**PRELIMINARY GEOTECHNICAL INVESTIGATION  
AND GEOLOGIC HAZARDS EVALUATION  
LATIGO TRAILS FILINGS 9 AND 10, 78 LOTS  
SOUTHWEST OF EASTONVILLE ROAD  
AND LATIGO BOULEVARD  
EL PASO COUNTY, COLORADO**

Project No. CS19409-115

August 3, 2021  
Revised March 31, 2022

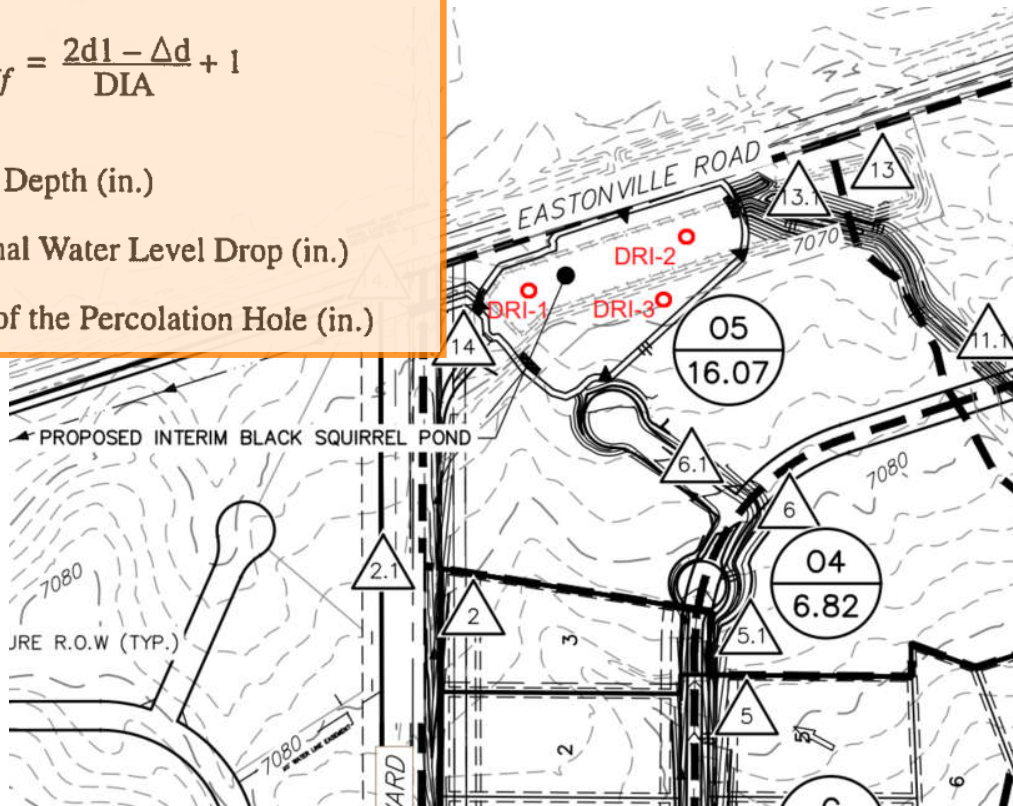
Explain how this was calculated. The city has guidance that includes an Rf equation, see screenshot above.
